**NRDC Comments on 40 CFR 192, Health and
Environmental Protection Standards for Uranium and
Thorium Mill Tailings, Proposed Rule, 80 Fed. Reg.
4156-4187 (Jan. 26, 2015), Docket ID No. EPA-HQ-
OAR-2012-0788.**

May 27, 2015

RE: Docket ID No. EPA-HQ- OAR-2012-0788, *Natural Resources Defense Council Comments on 40 CFR 192, Health and Environmental Protection Standards for Uranium and Thorium Mill Tailings, Proposed Rule.*

FIGURE 1:

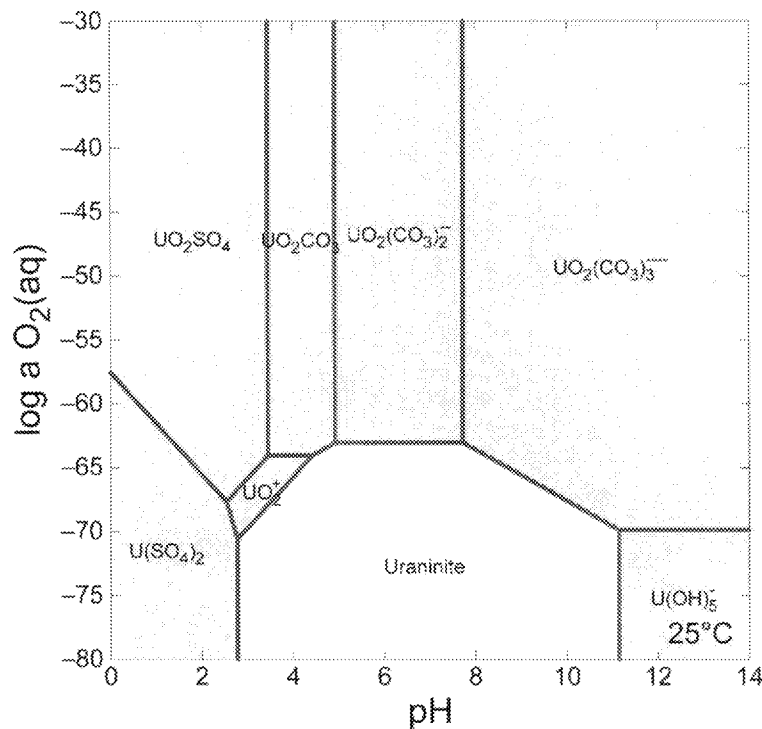
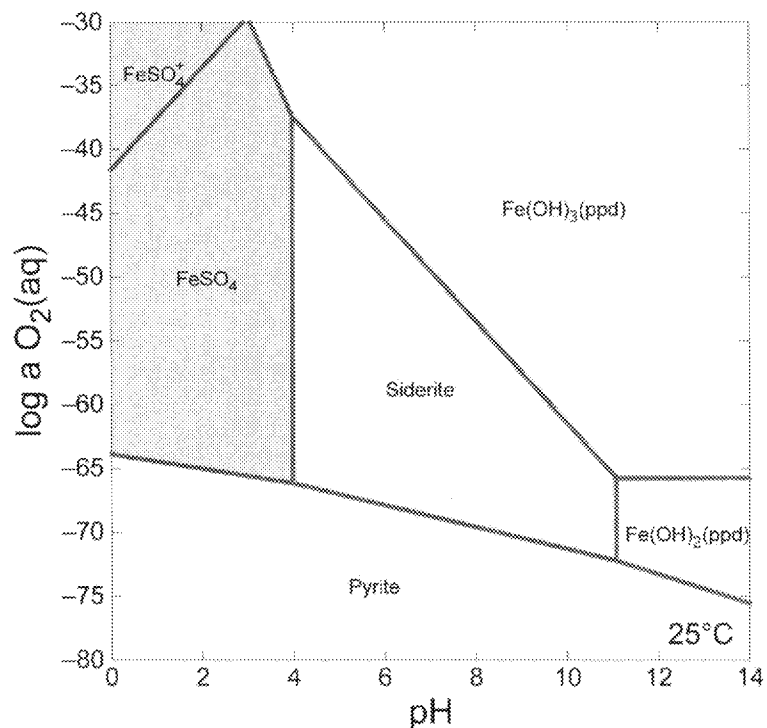
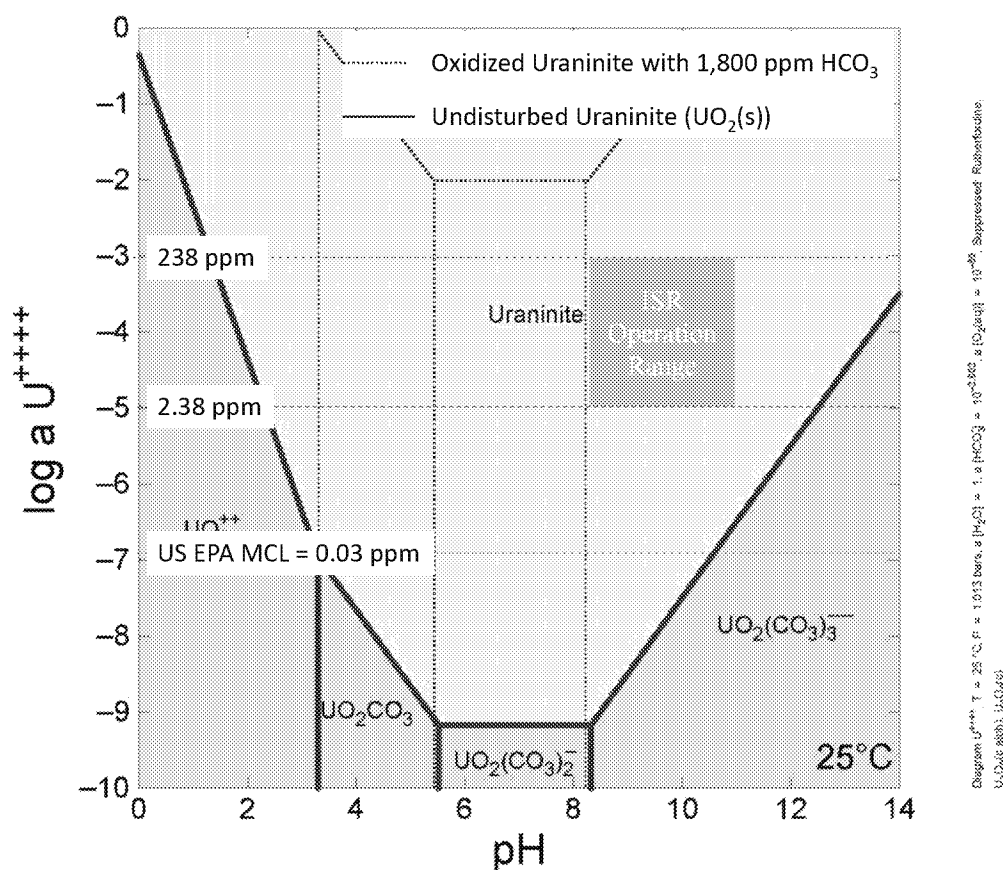
Below are Pourbaix diagrams displaying relevant geochemical conditions from Geochemist Workbench®. The top figure shows Iron and bottom figure shows the uranium stability fields.

The addition of a lixiviant and complexing agent to a reduced uranium ore creates a violent oxidation process which significantly alters the geochemistry and hence the solubility of uraninite in solution. These two conditions are signifying the incredible change in chemistry due to addition of lixiviant. The figure below, first produced today for these comments, demonstrates the theoretical change in uraninite solubility when no oxygen is present (solid red line) and when oxygen and carbonate is added to the model (dashed red line). The gray region approximates the geochemical conditions present when ore is extracted from the production zone. This significant change in geochemistry should make it apparent to EPA that there are substantial differences between pre-mining, original conditions and post-restoration conditions that have much less to do with the natural mineralized state of the water.

FIGURE 2

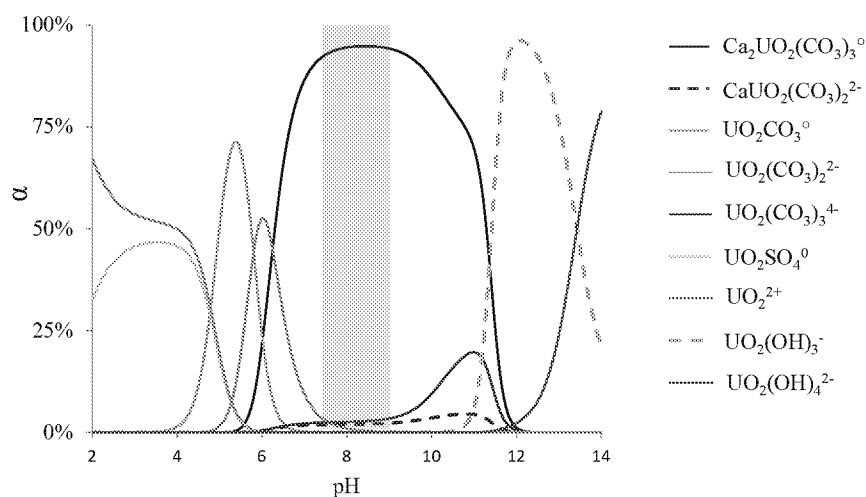
interacts with a ligand. Uranium can conceivably exist as several species given the specific conditions of the solution (See figure below).

Fox et al. (JTI058 at p. 8) demonstrated that the presence of calcium and carbonates have significant impact on uranium adsorption to reactive mineral surfaces. This is due to the formation of calcium-uranyl-carbonate complexes ($\text{Ca-UO}_2\text{-CO}_3$) which are thermodynamically stable under those conditions. Kelly et al. (JTI059) observed evidence of the existence of these species with spectroscopy and thermodynamic speciation calculations predicted geochemical stability ranges. These measurements provide direct evidence for the existence of these complexes and consistency was established with thermodynamic speciation calculation predictions, which were used in my geochemical model below.

We've created the figure below using a geochemical modeling software (PHREEQC v.3.1.2) using an updated thermodynamic database which includes the formation of the $\text{Ca-UO}_2\text{-CO}_3$ complexes and representative average stability data from Christensen Ranch ISL mine unit 5. The pH was the master independent variable and average post-restoration constituent concentrations were held constant. The shaded grey region shows the range of measured pH values from the stability samples at Christensen Ranch. The table below the figure shows the input data into the thermodynamic database and model. This figure shows, unequivocally, that the representative geochemical conditions in the aquifer post-restoration are largely dominated by $\text{Ca-UO}_2\text{-CO}_3$ complexes predicted by the updated thermodynamic database. This evidence demonstrates that NRC and industry are using outdated assumptions about uranium geochemistry and transport, and EPA should, at a minimum, incorporate the updated science into its reasons for the rule. .

FIGURE 3: THEORETICAL REACTIVE TRANSPORT MODEL FROM AN ISR SITE DISPLAYING THE

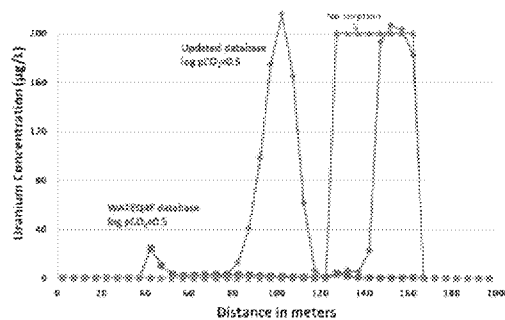
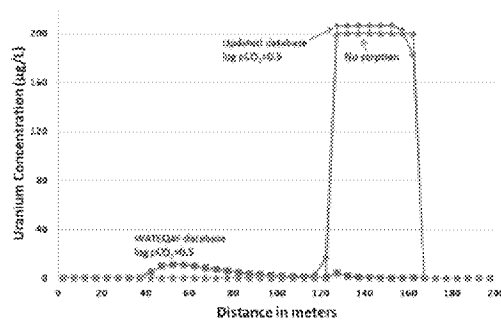
These older models are problematic for accurately predicting the rate at which uranium moves through the groundwater. According to the USGS and the geochemical conditions modeled, within 25 years the front edge of the uranium plume was predicted to migrate roughly 165 m (See figure above). More importantly is the vast difference between model results for the updated thermodynamic database (Blue) and the outdated thermodynamic database (Red) suggesting that uranium transport from ISR sites is grossly underestimated and transport of high levels of uranium concentrations beyond the well field could reasonably occur within the span of a human life time or a matter of decades once hydraulic control is lost or absent.

FIGURE 4: A) COMPARISON OF BASELINE AND STABILITY MONITORING FOR CHRISTENSEN RANCH MINE UNITS 2-6 AND B) CUMULATIVE HISTOGRAM OF GROUNDWATER URANIUM CONCENTRATIONS

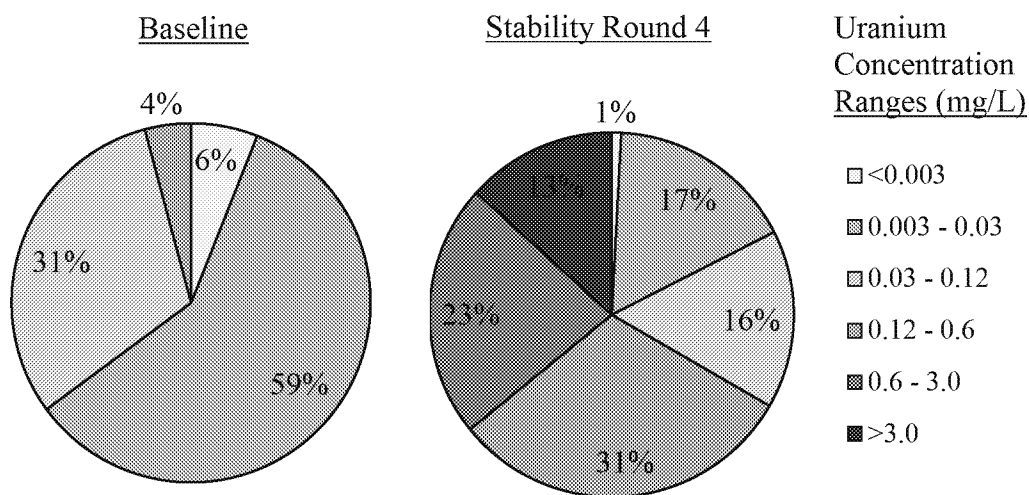
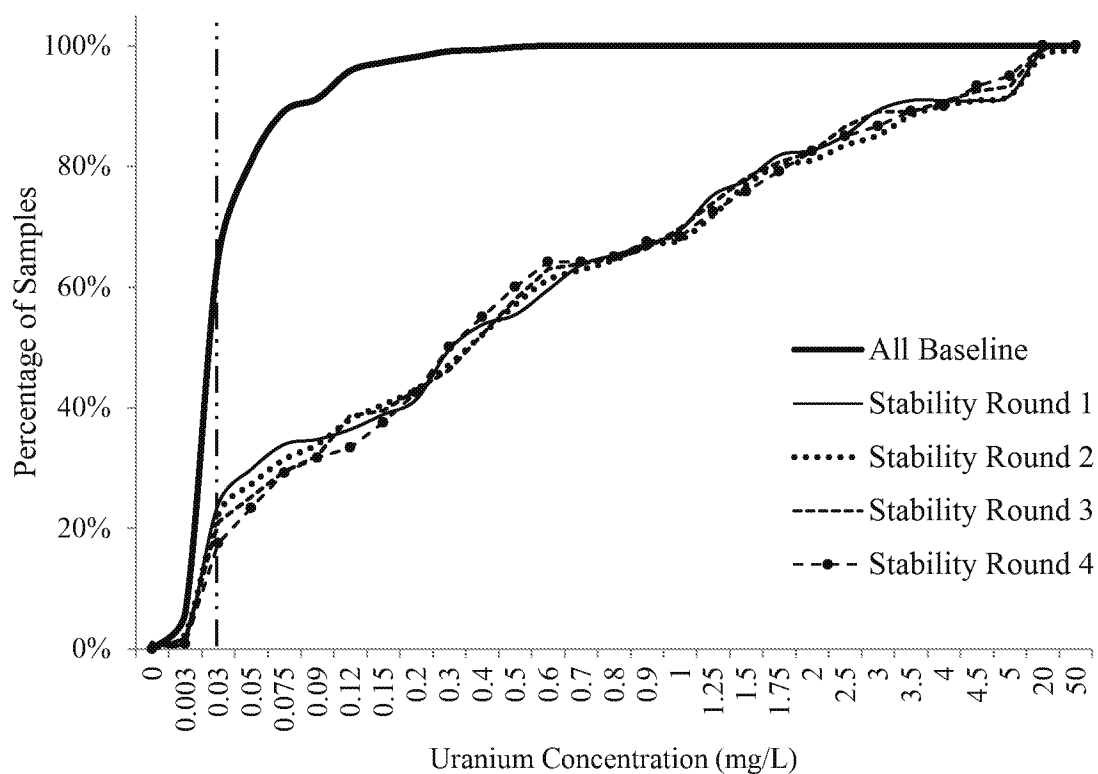
We provided a cumulative histogram for groundwater data from the Christensen Ranch ISL site (Figure 4; Comment #57). The results demonstrate that approximately 65% of all baseline samples (n = 433) were <0.03 mg/L, 31% were between 0.03 – 0.12 mg/L, and 4% were between 0.12 - 0.60 mg/L (Figure 4A). After ISL and groundwater operations at Christensen Ranch, the groundwater quality distribution observed substantially elevated uranium concentrations. Post-Restoration stability sampling round 4 results observed approximately 18% of the groundwater sample were <0.03 mg/L, 47% between 0.03-0.60 mg/L, and two new categories of elevated uranium concentrations were observed which

observed 23% of samples were 0.6 - 3.0 mg/L, and 13% were >3.0 mg/L (Figure 4A).

Examining the groundwater quality distribution cumulatively for each post-restoration round circumvents issues with sporadic data trends for a given well (Figure 4B). The data suggests that the groundwater quality distribution across all mine unit samples display little appreciable temporal changes. If natural attenuation mechanisms were substantially decreasing the net uranium mass in groundwater, the post-restoration data distribution trends would progressively trend back to the baseline distribution. However, there's little difference between round 1-4 stability sampling distributions, suggesting the net groundwater uranium mass is staying relatively constant throughout the stability sampling period.

FIGURE 6

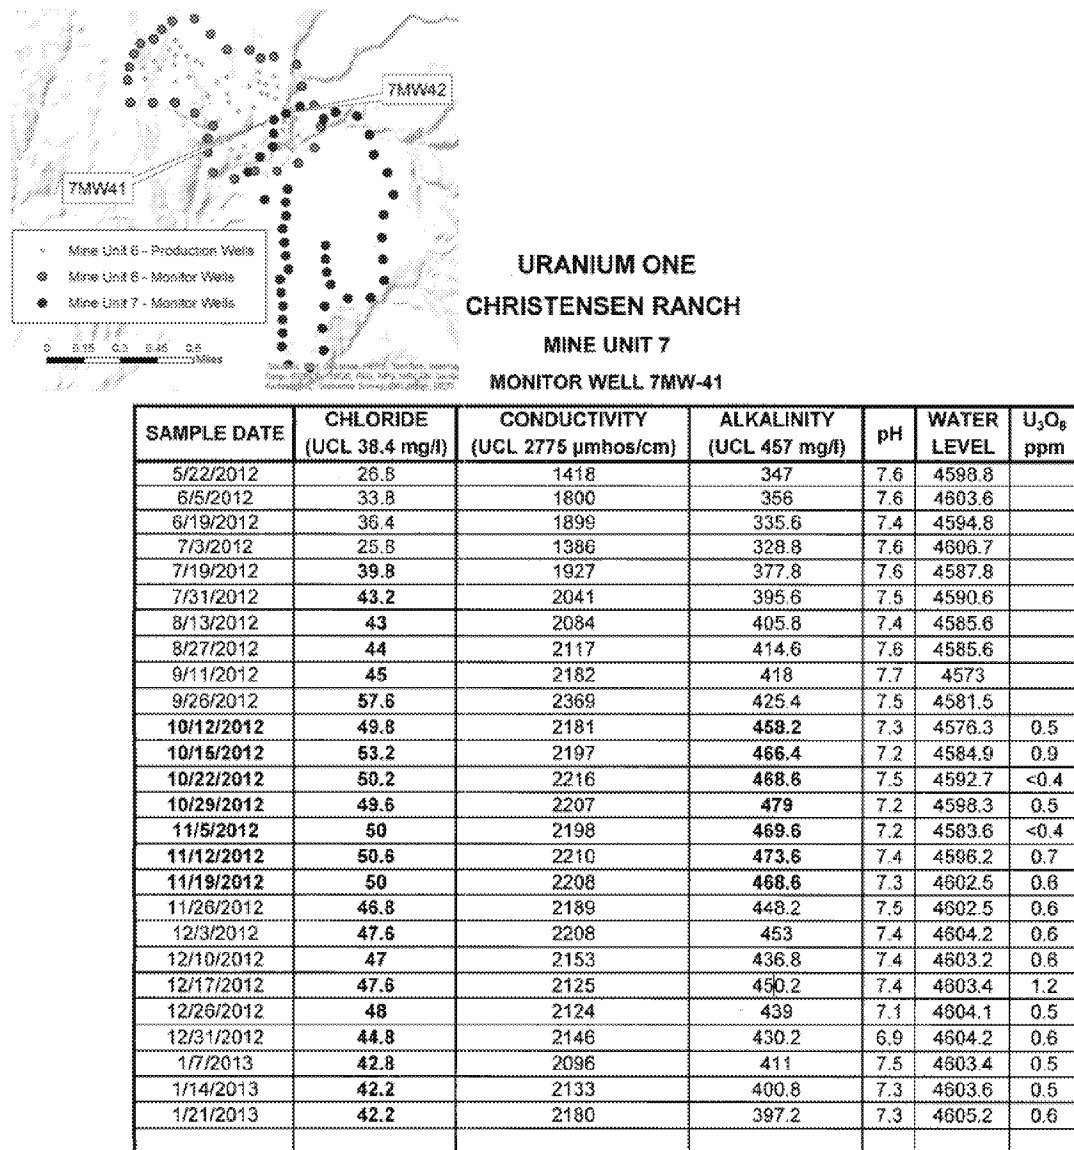
Further, the current use of UCLs masks potential impacts to surrounding and adjacent aquifers. As one example from the Willow Creek ISL site, baseline water quality samples were taken from well 7MW41 between 10/28/1997 and 12/4/1998.¹²⁵ Average concentrations of chloride, conductivity (reported as electrical conductivity or EC), alkalinity, and uranium were as follows, respectively: 7.2 mg/L, 855.5 umho/cm, 91.7 mg/L as CaCO₃, and 0.0004 mg/L.

The table was taken from when the excursion report specifically for well 7MW41 (ML13037A321) and the inset map shows the location of 7MW41 located within the production zone of MU6 and the spatial overlap of monitoring wells into production zones. Note that mine unit 6 had applied for restoration approval by the NRC but was denied (JTI035).

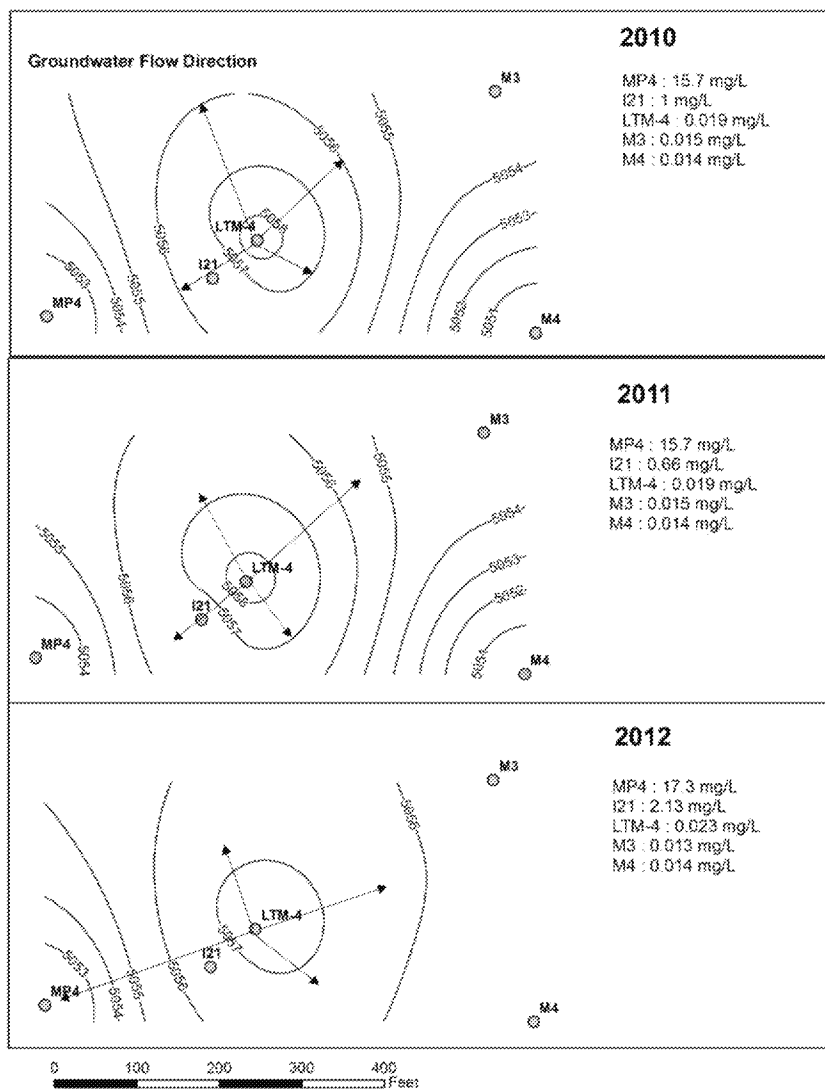
However, the 'water level' data¹⁴² suggest that the groundwater flow direction was moving away from LTM-4, not towards it (Figure 8). According to hydrogeology, groundwater flows from high to low potentiometric surface.

With this information regarding the science and history of fluid excursions, EPA's rule must require all ISL sampling, throughout all stages of operations, to include proper sampling methods, quality control, and sample documentation before it accepts *any* groundwater samples. Furthermore, these analytical sampling techniques *must be required* in accordance with EPA guidelines) or scientific based Standard Methods). The use and reliance of an unknown, inconsistent, and inadequate analytical technique does not support a scientifically defensible excursion monitoring program and calls in to question much of the assumptions of 'slow', 'lock-in', or 'naturally attenuated' uranium transport behavior. In other words, if uranium is not detected, above an extremely high detection limit, then industry and regulators will be able to assume that it is lagging behind the lixiviant plume. This is not consistent with the empirical data, nor the current understanding of the non-reactivity of Calcium-uranyl-carbonate complexes.
